Service Bulletin

REFRIGERATORS

REF 01-09

INTERNAL MOISTURE: FROST / ICE ACCUMULATION SWEATING / LEAKING WATER

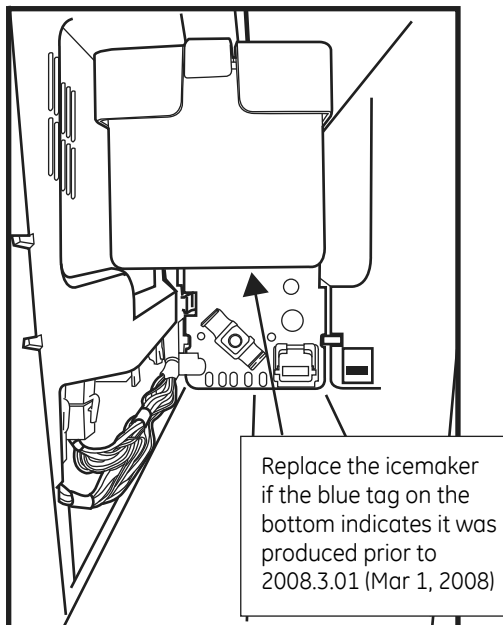
When the icemaker dumps ice cubes to the ice bucket, ice cubes jam between the icemaker and the liner. The icemaker makes a loud noise and eventually stops working.

Replace both the icemaker **WR30X10097** and the mainboard **WR55X10763** if they meet the following criteria:

Replace the icemaker if the blue tag on the bottom indicates it was produced prior to 2008.3.01 (March 1, 2008).

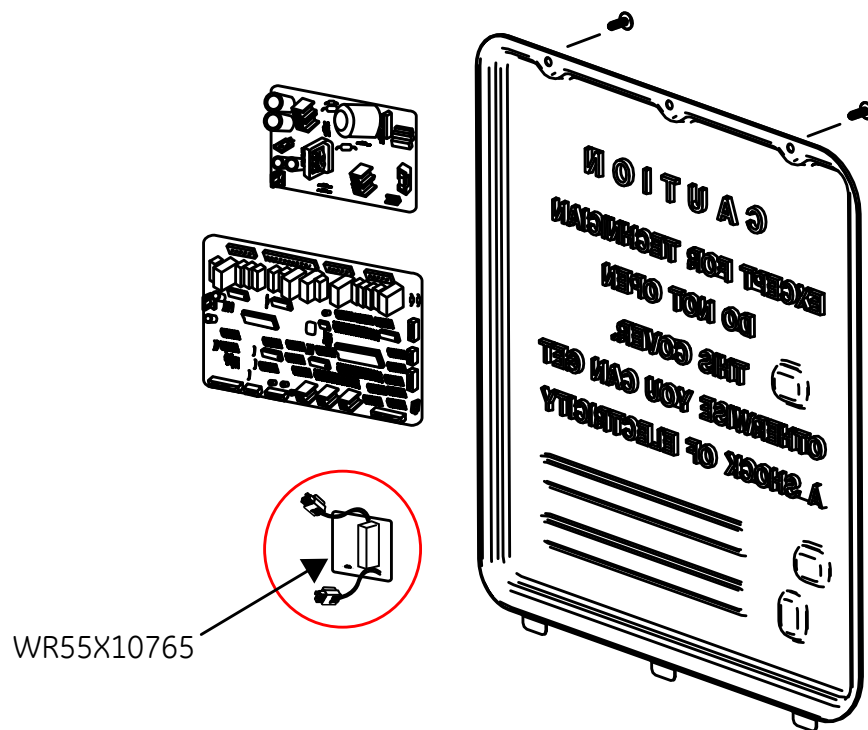
The fresh food lighting is provided by LED's located at the top of the cabinet and behind the vegetable bins in the fresh food section.

If the LED lights flicker, or are dim, replace the LED light board, part number WR55X10765. The LED light board is located inside the main board enclosure on the back of the refrigerator.
